PRELIMINARY OVERALL DEVELOPMENT PLAN

UNIVERSITY PARK ESTATES APARTMENT COMPLEX

INFORMATION SHEET FOR
PRELIMINARY OVERALL AREA DEVELOPMENT PLAN
(P.O.A.D.P.)

Re: University Park Est.
XX Preliminary Plan
☐ P.O.A.D.P.

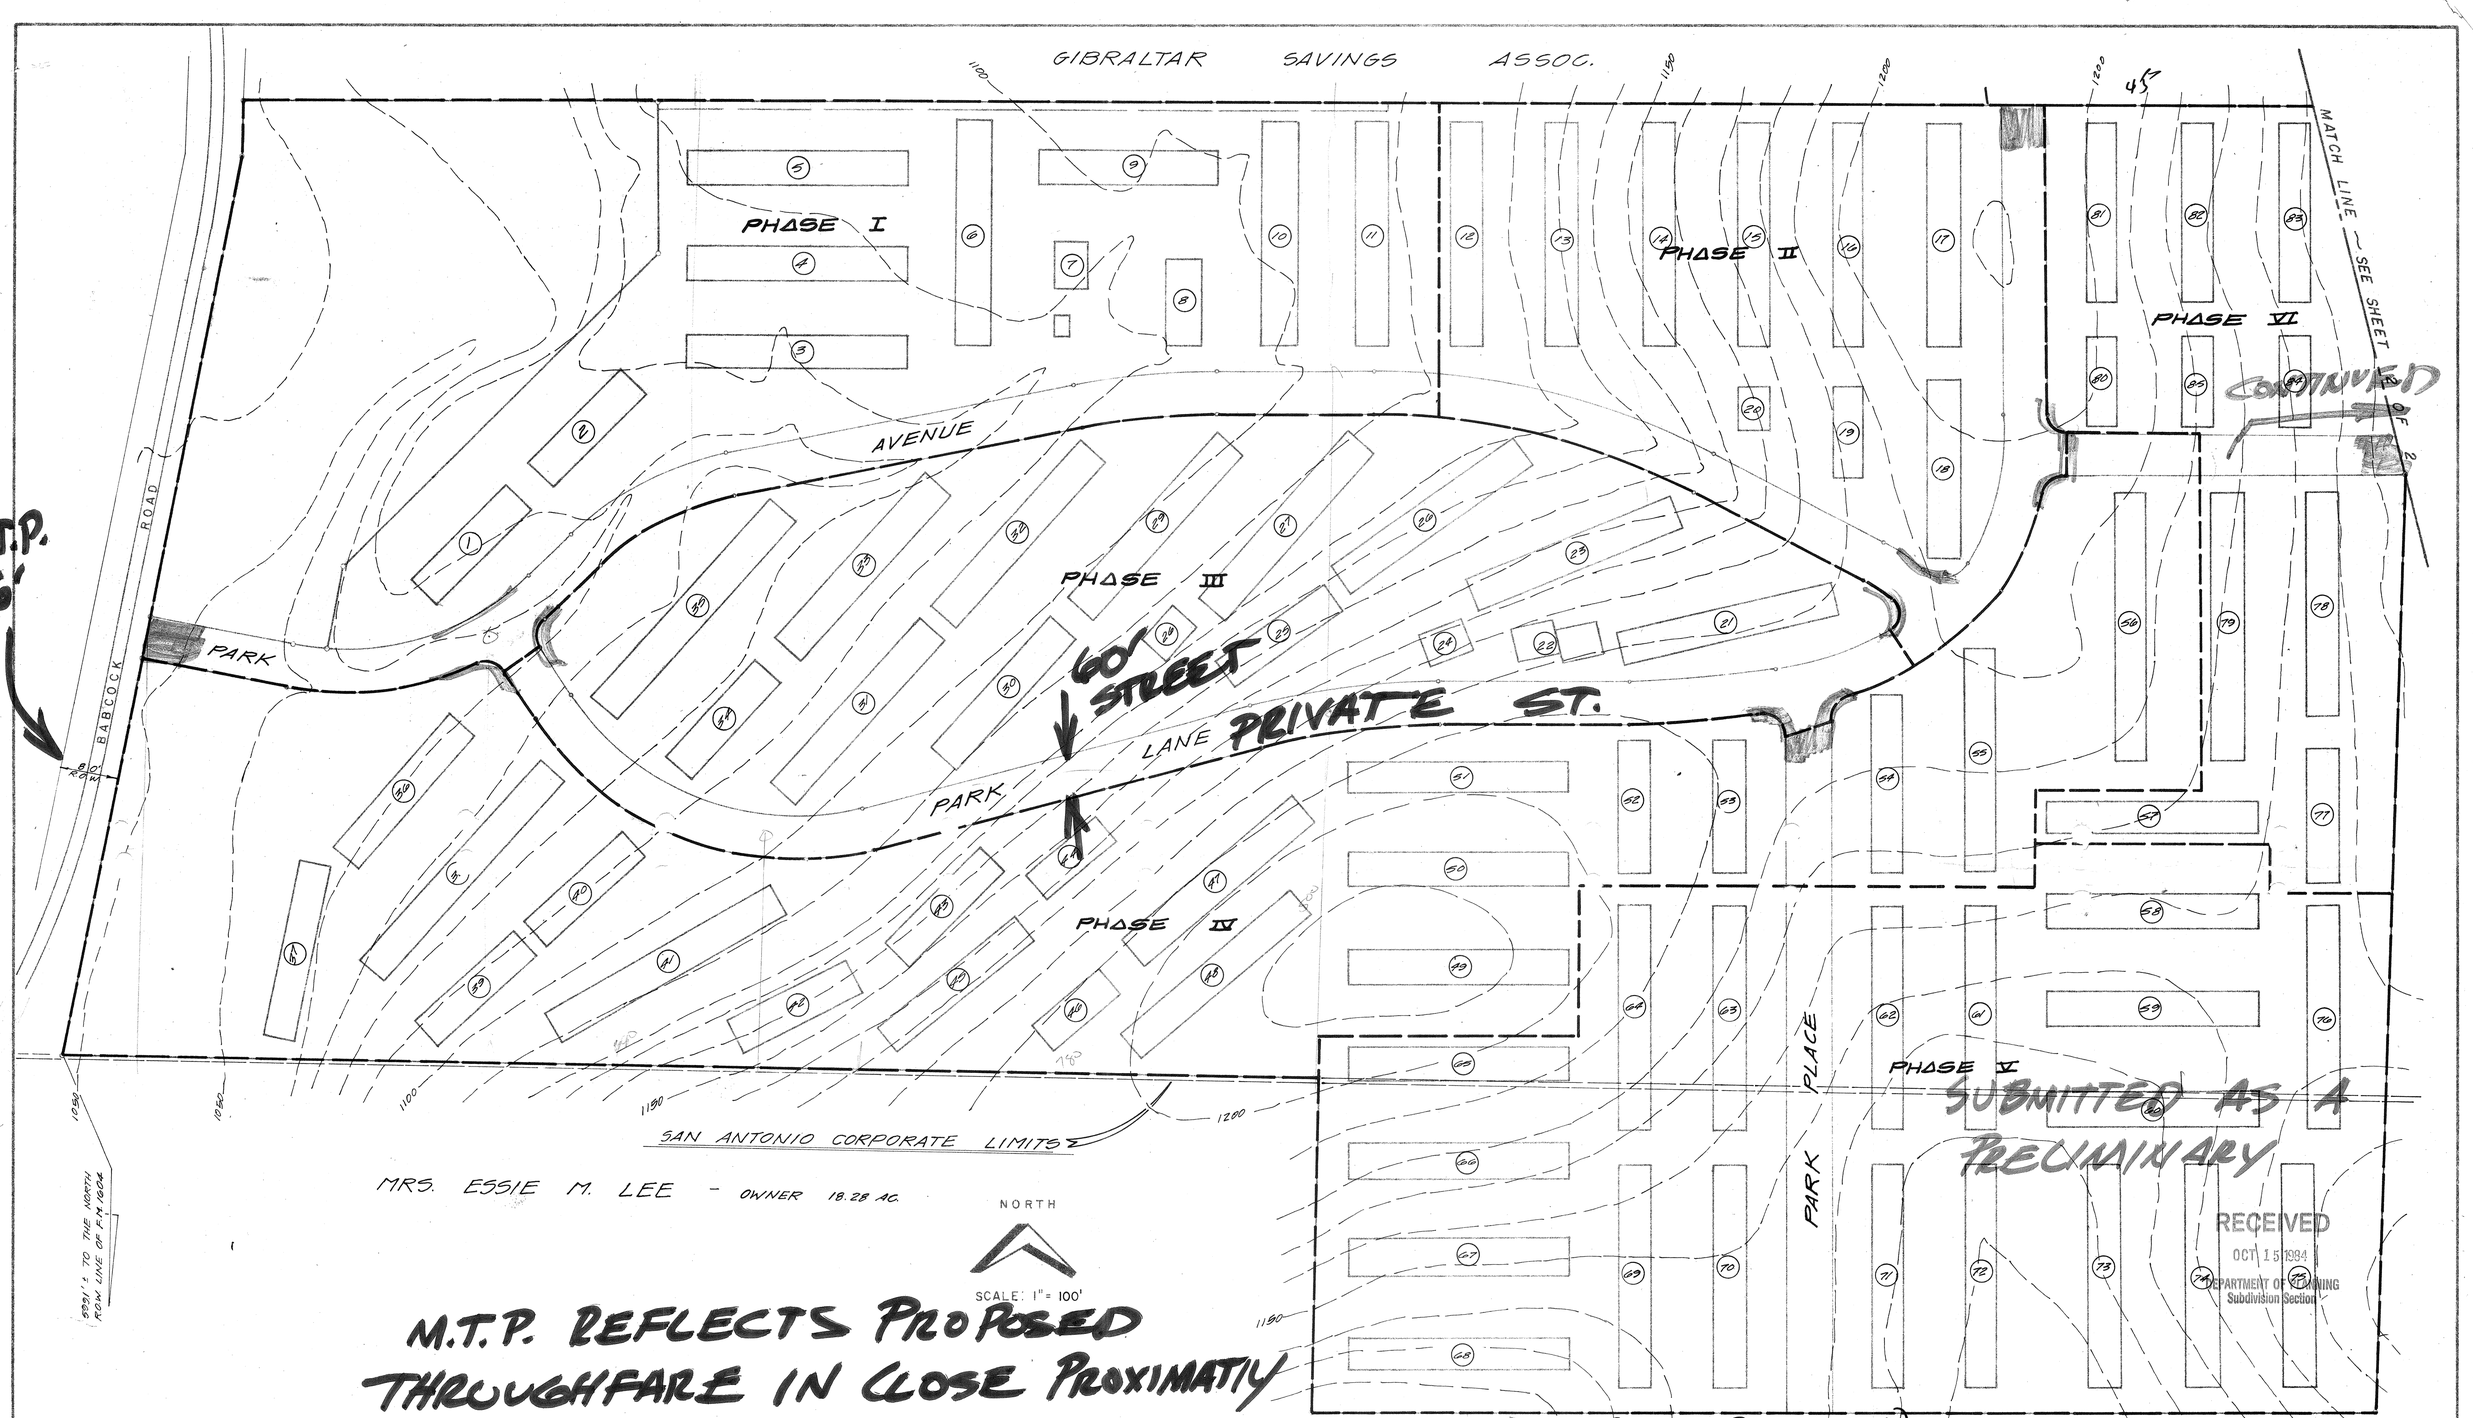
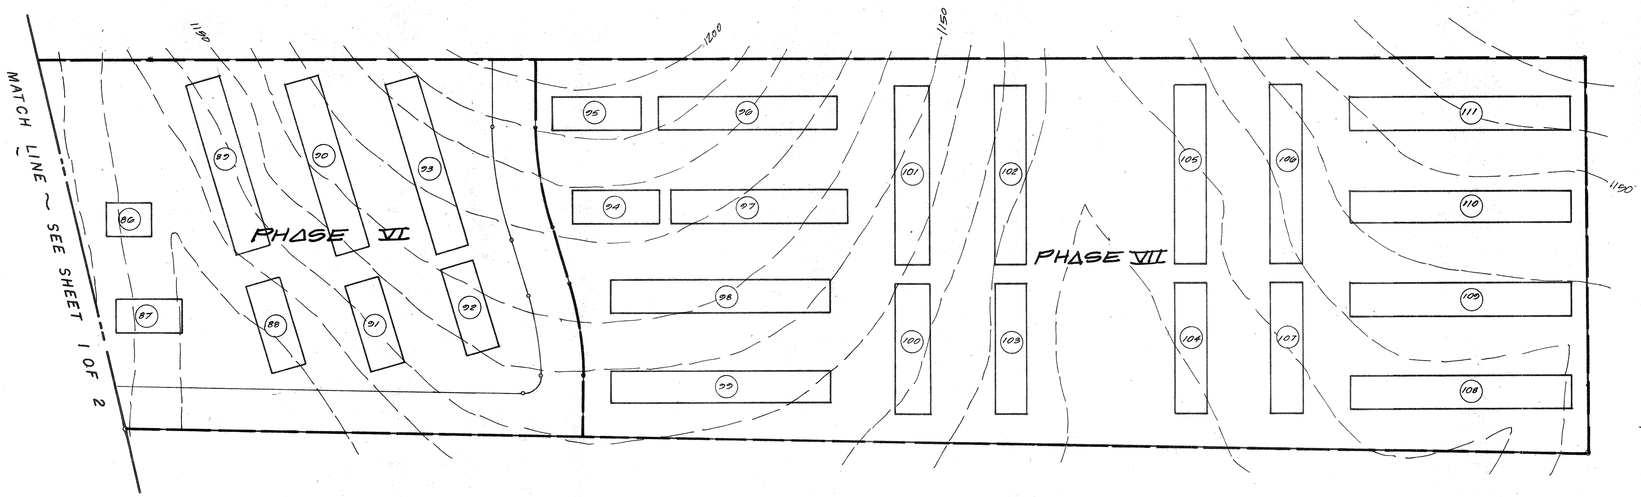
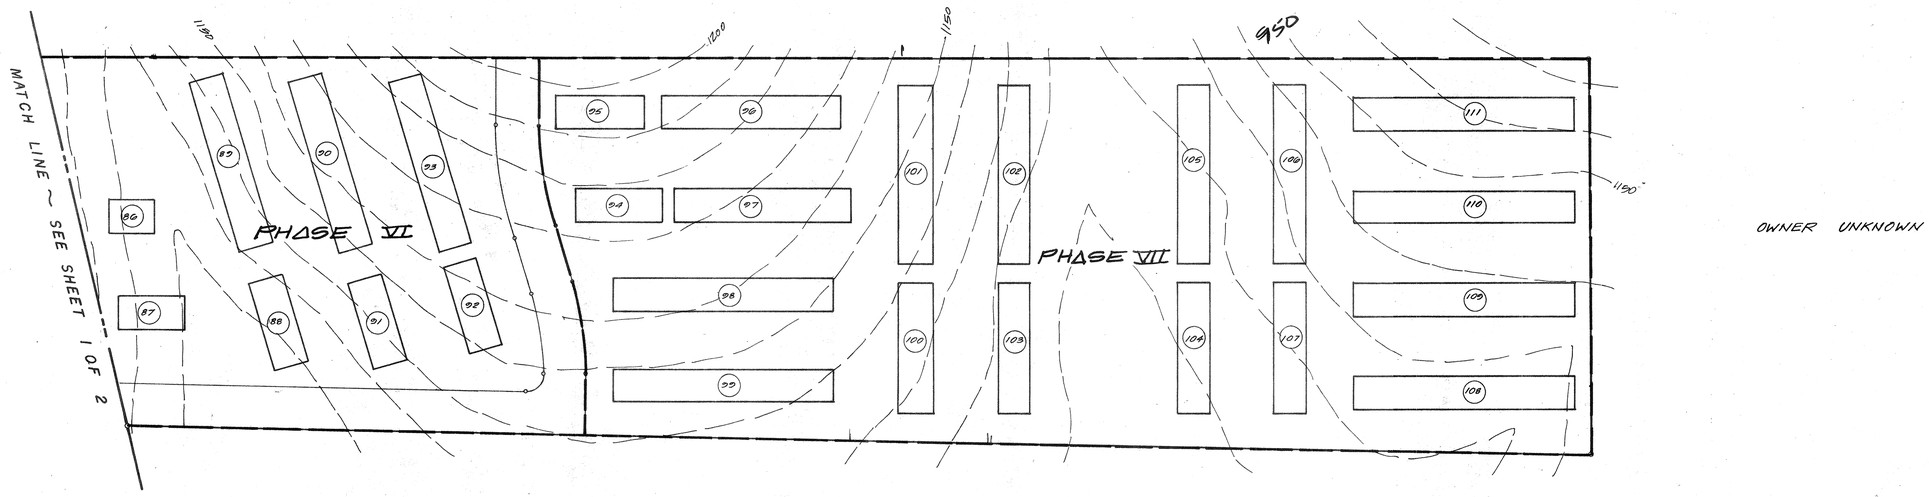
COMMENTS: COMMITTEE REVIEW 10-15-84. Committee felt there was a need to meet with Robert to discuss north-south connector if possible thoroughfare needs across property. Before we meet all will contact surrounding property owners to determine street needs in the area. Additional staff opinion is that expected development (Apt) will mandate a thoroughfare in this area. 10-19-84 Called Robert out of town, secretary not in office. They will return call.

The staff met with Robert Diaz De Leon & Mr. Sing (engineer). Discussion involved the possible north-south street connection & major thoroughfare needs across property (86' facilities). Staff is of the opinion that the expected volumes of traffic generated by 5000 units warrants the street. Robert indicated that although streets are designated as private, all internal streets will be constructed to city standards. In order to determine the street alignments, there was a concensus that we would bring all adjacent property owners together. Worth Tract, Balser/Wender and the P.O.A.D.P. applicant. We will set up meeting for Tuesday - Nov. 1, 1984.

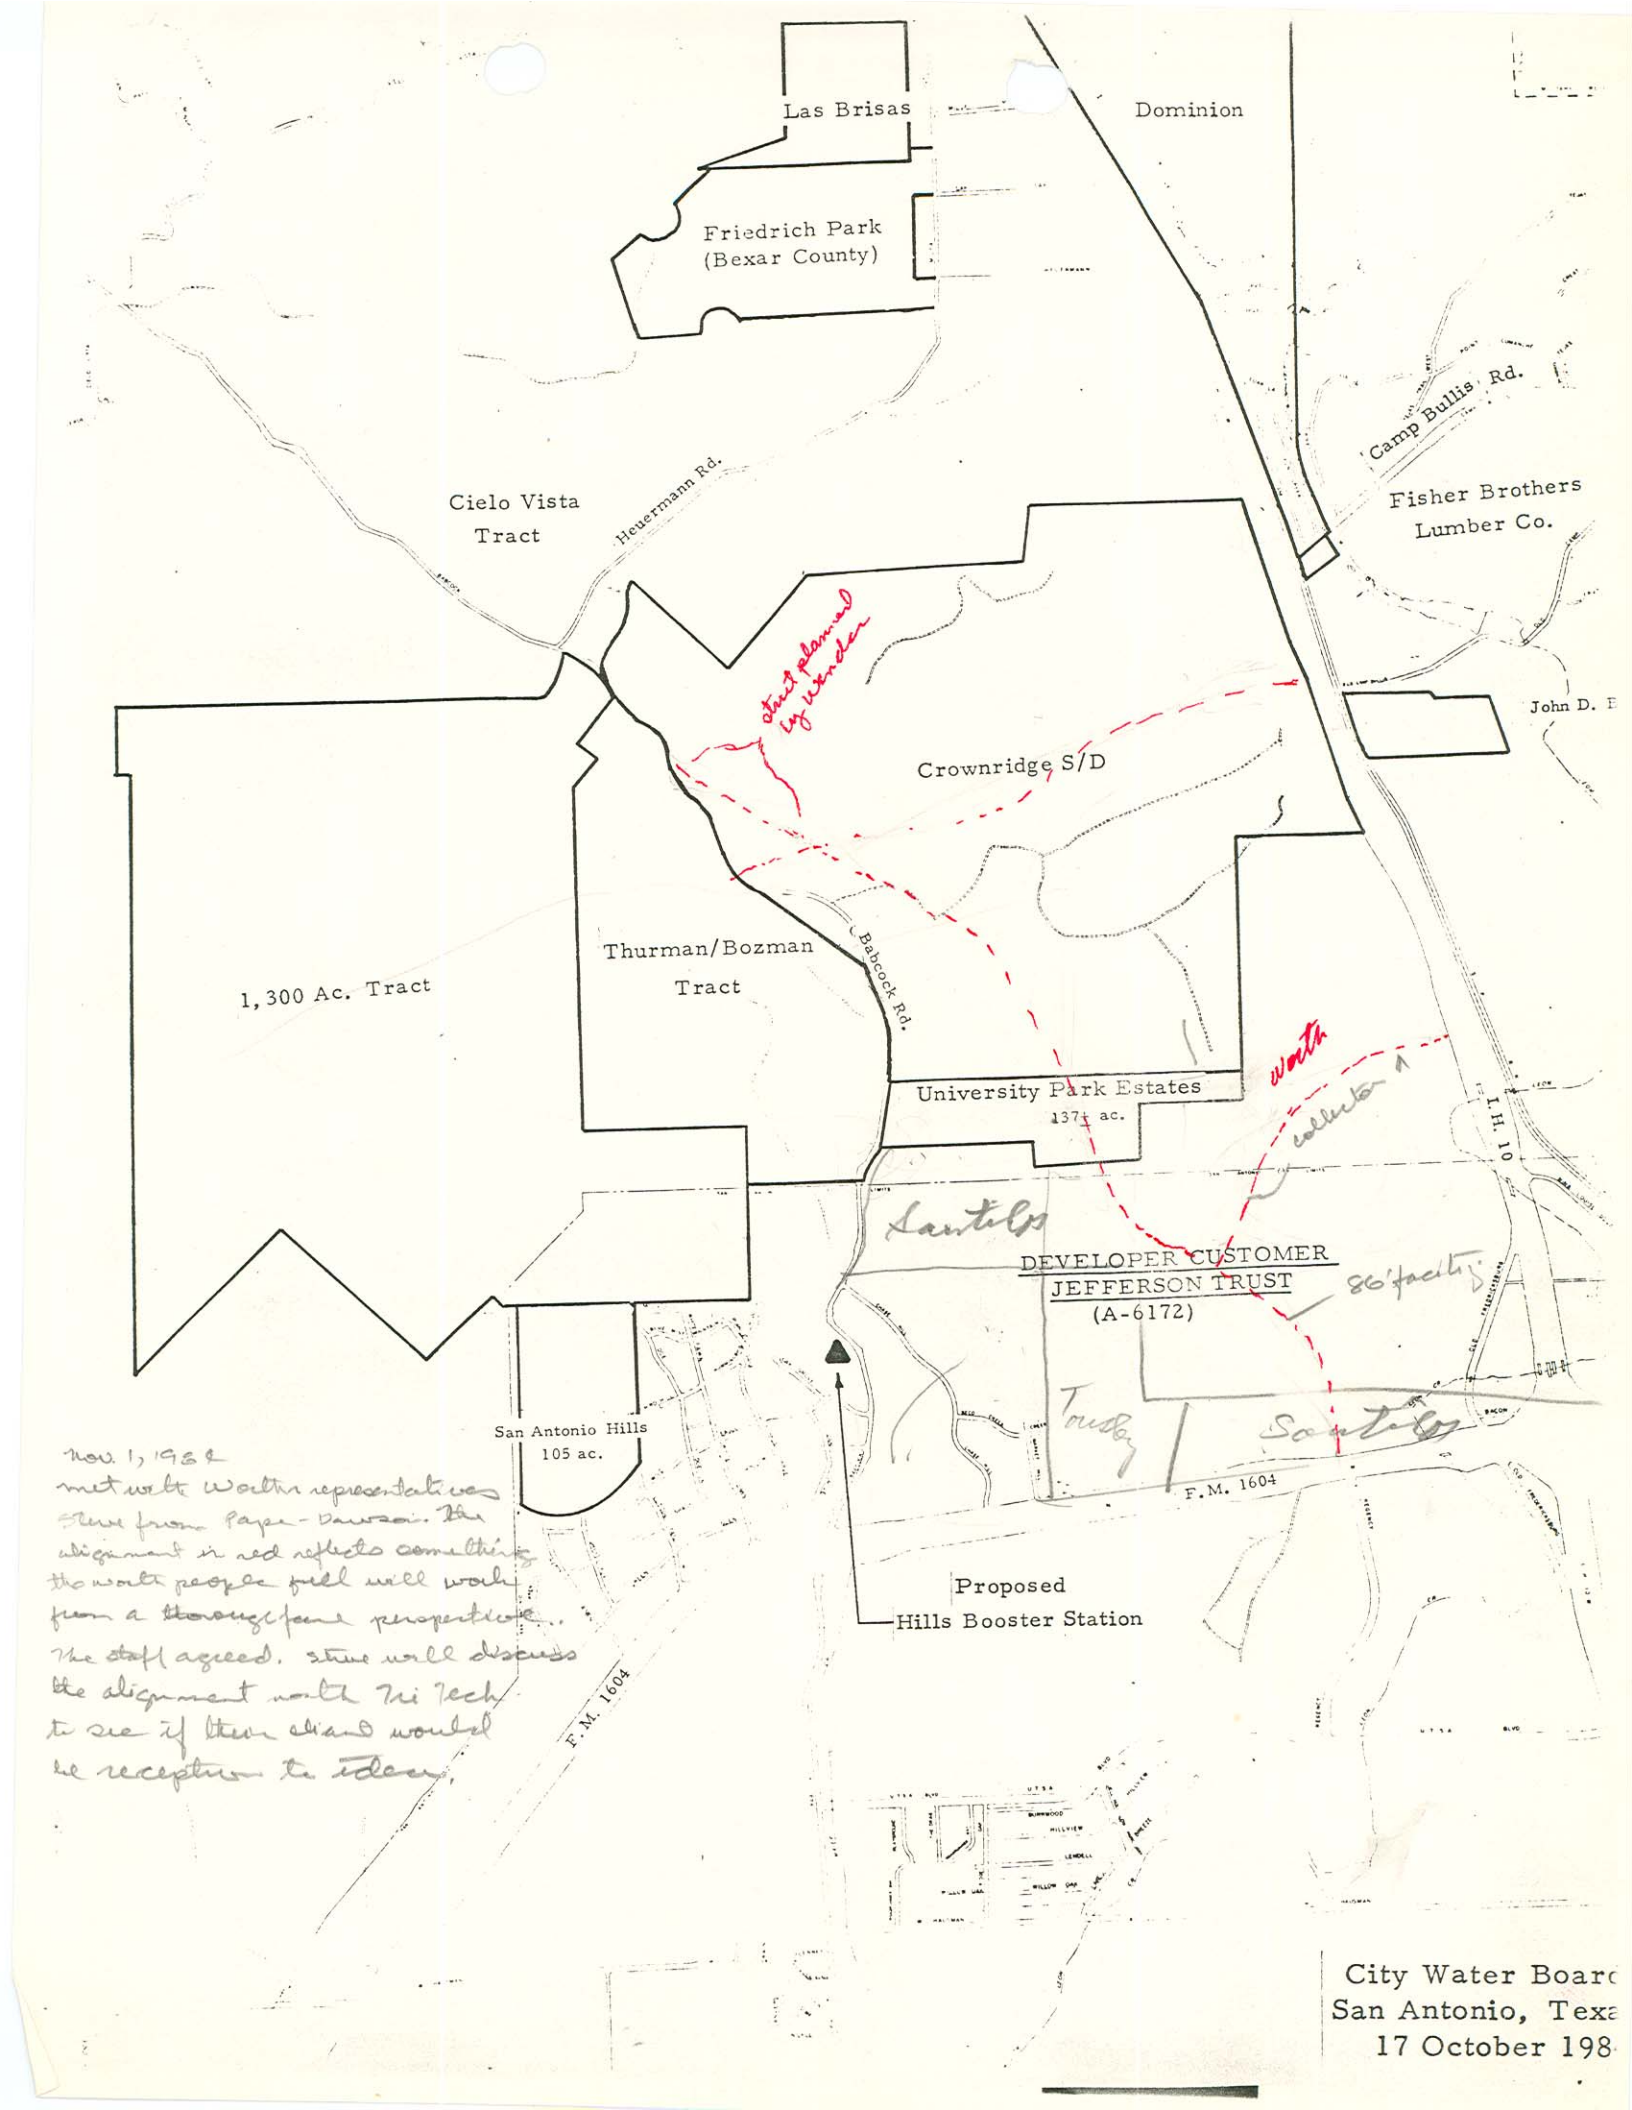
Nov. 1, 1982
met with Worth representatives
Steve from Pape-Dawson. The
alignment in red reflects something
the north people feel will work
from a thoroughfare perspective..
The staff agreed. Steve will discuss
the alignment with Mr Tech
to see if there would
be reception to idea.
